Product Change Notification

1. ECR #: 231075
Notification #: 714

- QRM8 - .8mm (.0315") Q Rate™ Terminal with Edge Rate Contacts

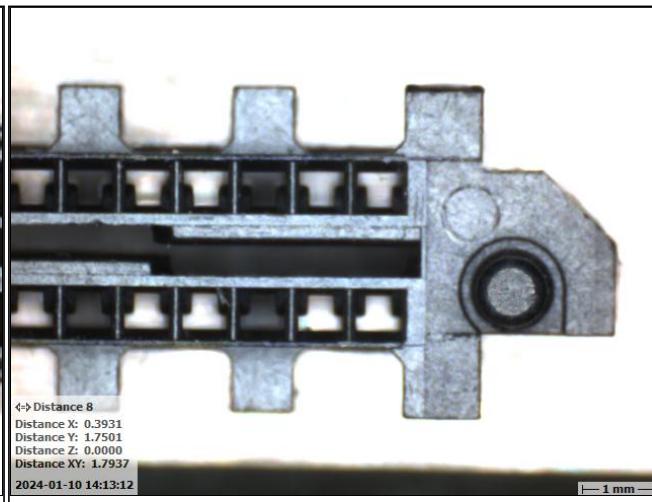
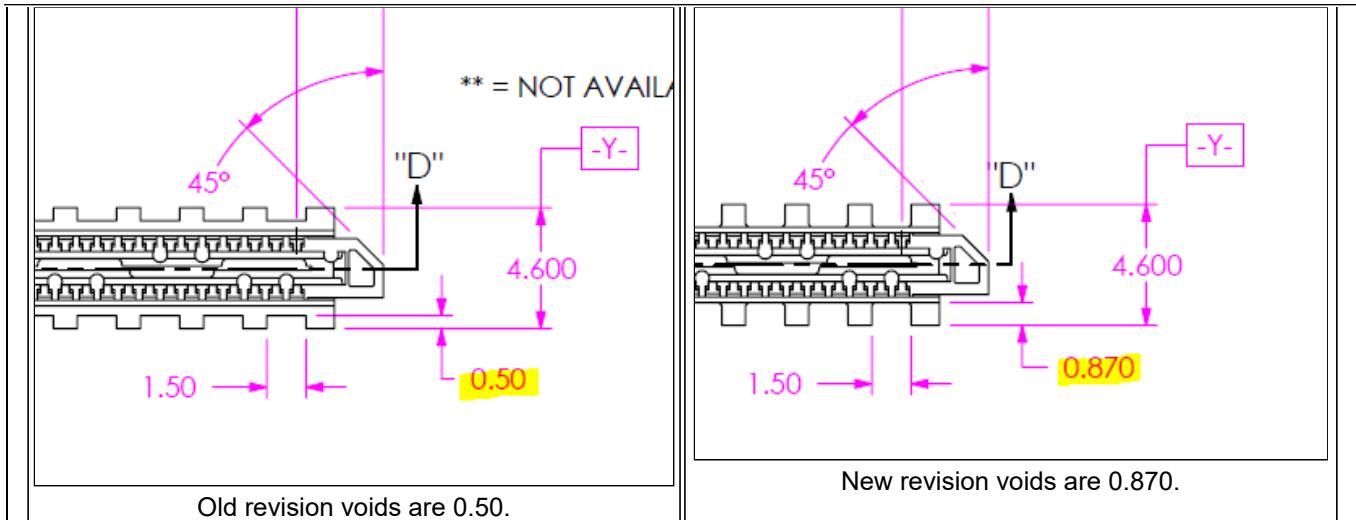
The voids along side the body have been made larger.

The voids along the bottom side of the body are larger on the new revision.

Smaller voids on old revision.

Voids are larger on new revision

This change was intended to improve moldflow and flatness of the body resulting in improved coplanarity of the assembled connector.
